Access Compliance Report

Public Rights-of-Way

Intersection ID: 31656	Main Street: CALTON_LN	Cross Street: CRYSTAL_ERICA_LN	Location: NE
ADA ID: 934F5F1F968C	Ramp Type: Combination1	Initial Pass/Fail: Fail	Overall Compliance: No
			Severity Score: 58.75

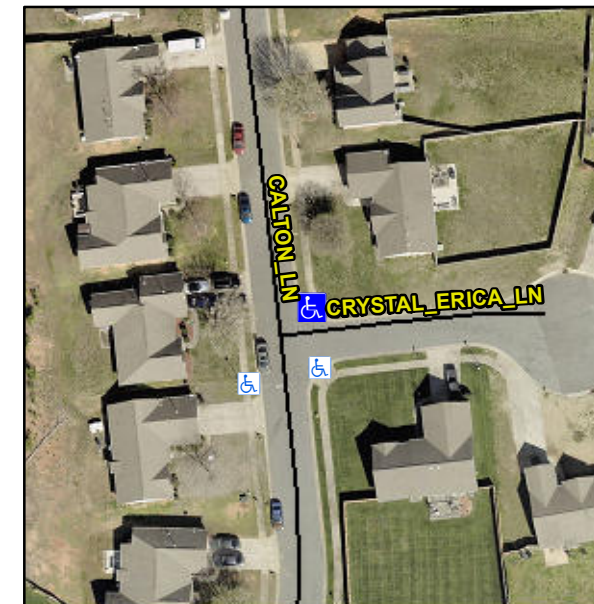
Not Found, R304.5.1, R304.5.3, R304.3.2

Compliance	Description	Data	Compliance	Description	Data
N/A	Ramp Length LT (in)	45.0	N/A	Ramp Length RT (in)	N/A
Yes	Ramp Width LT (in)	48.0	N/A	Ramp Width RT (in)	N/A
No	Ramp Slope LT (%)	13.4	N/A	Ramp Slope RT (%)	N/A
No	Ramp XSlope LT (%)	9.8	N/A	Ramp XSlope RT (%)	N/A
N/A	Ramp Length (in)	51.0	Yes	Ramp Slope (%)	6.3
No	Ramp Width (in)	42.0	No	Ramp XSlope (%)	8.1
N/A	Flare Type LT	N/A	N/A	Flare Type RT	N/A
N/A	Flare Slope LT (%)	N/A	N/A	Flare Slope RT (%)	N/A
N/A	Flare Traversable LT?	N/A	N/A	Flare Traversable RT?	N/A
N/A	Landing Length (in)	N/A	N/A	DWS Provided?	N/A
N/A	Landing Width (in)	N/A	N/A	DWS Contrast?	N/A
N/A	Landing Slope (%)	N/A	N/A	DWS Length (in)	N/A
N/A	Landing X Slope (%)	N/A	N/A	DWS Full Width?	N/A
N/A	Landing Curb? (Y/N)	N/A	N/A	DWS Offset (in)	N/A
N/A	Shared Landing?	N/A			
N/A	Gutter Ponding?	N/A	N/A	Gutter Slope (%)	N/A
N/A	Gutter Lip Ht (in)	N/A	N/A	Gutter X Slope (%)	N/A
N/A	Painted X Walk1?	No	N/A	Painted X Walk2?	N/A

Remove & Replace Entire Ramp.
